Revision Transmittal Sheet

This sheet transmits Revision 1 to Alert Service Bulletin ASB-328J-28-014 titled: FUEL – Inspection of drain installation for auxiliary fuel tanks.

Model Dornier 328J

No. ASB-328J-28-014 Rev. 1

**Fig.1**Model Dornier 328JRev. No. 1No. ASB-328J-28-014Rev. Date. Jul 08, 2004Date of Issue June 08, 2004Page 7 of 8

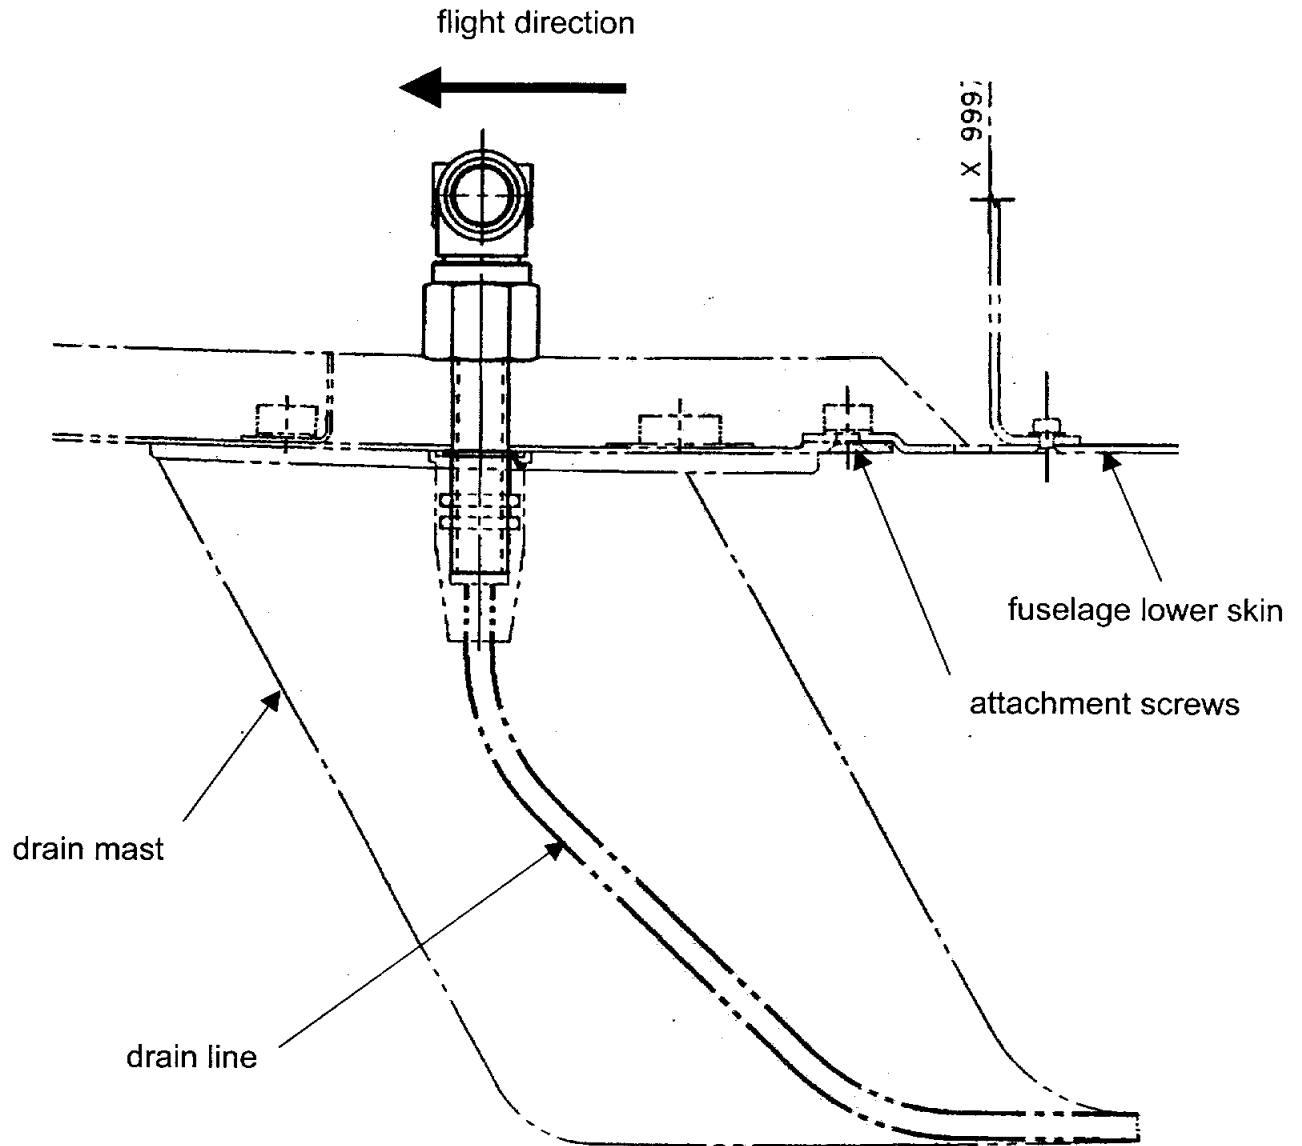
NOTE: Additional sealing of the plugs with adequate sealing compound (CML No. 09-010 or equivalent) may be necessary.
If necessary, remove drain mast (see Fig.1) for easy connection.

Fig.2

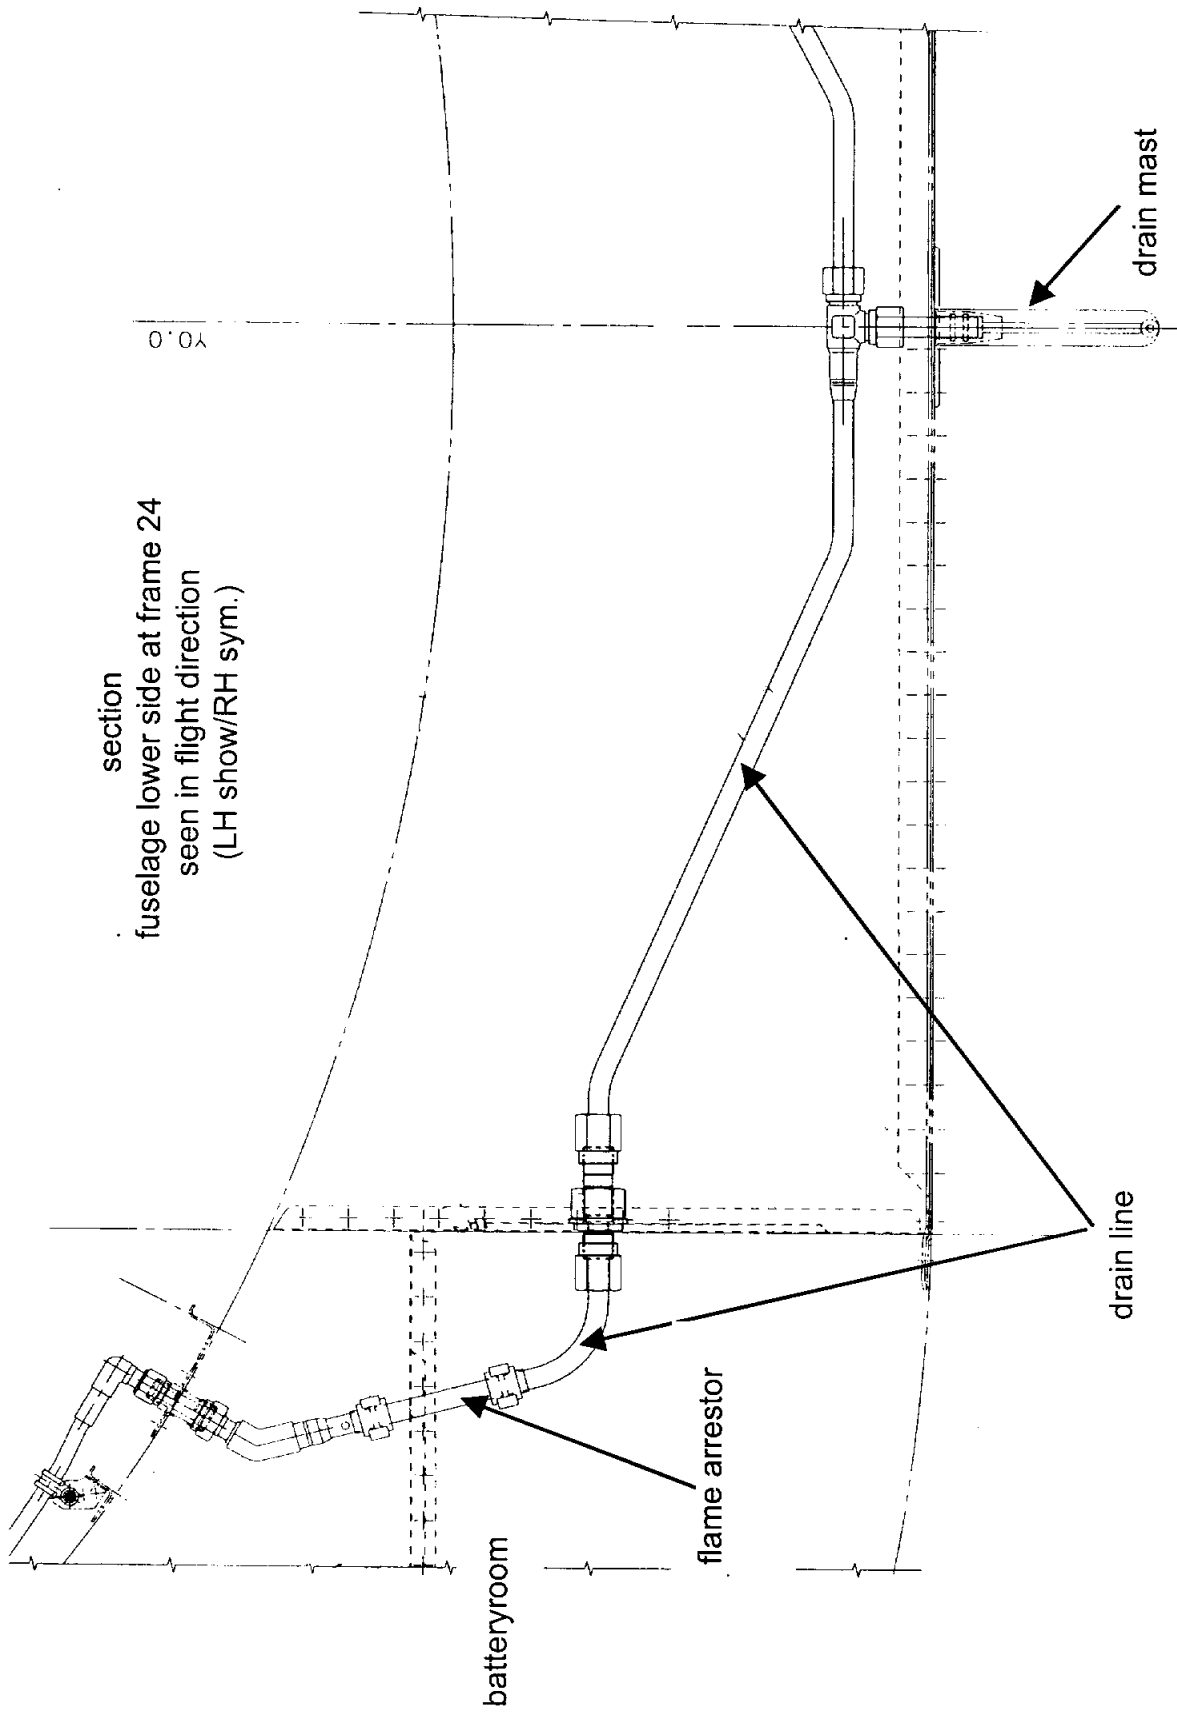
Page 8: Fig. 2 added

- (a) Open wiggins-clamps (refer to AMM JIC 20-30-19) and remove flame arrestor; refer to Fig. 2.
- (b) Check flame arrestor for blockage/ foreign objects:
If the flame arrestor was blocked, the initial pressure test must be repeated even when performed according Alert Service Bulletin ASB-328J-28-014 initial issue.

- (c) Clean flame arrestor; use dry cleaning solvent CML No. 11-001 or equivalent.
- (d) Using pressurized air, check that the drain lines from flame arrestor upwards and downwards are not blocked/clogged;

- (e) Re-install flame arrestor; use new o-rings (item no. 1) for wiggins clamps.
